Sealing Recommendation For Labelled Tubes

When sealing tubes that have had labels by Berry Astrapak we recommend the following sealing guidelines:

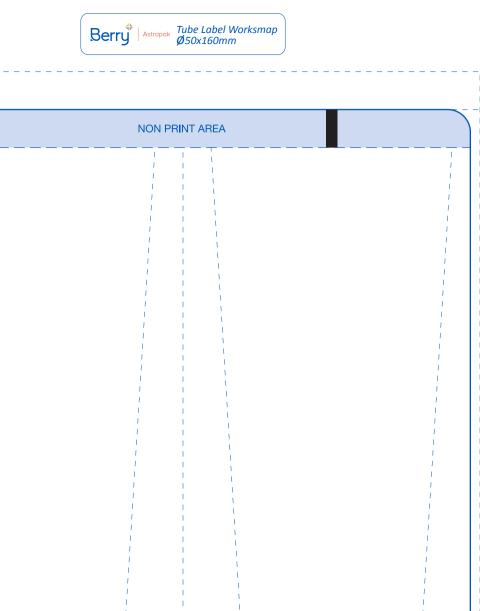
- The space between the cap and the base of the label should be a minimum of 5mm
- The space between the top of the label and the sealed area should be a minimum of 5mm
- The sealed area should have a minimum height of 7mm and a maximum of 10mm
- There is a 2mm above the sealed area allowed for trimming
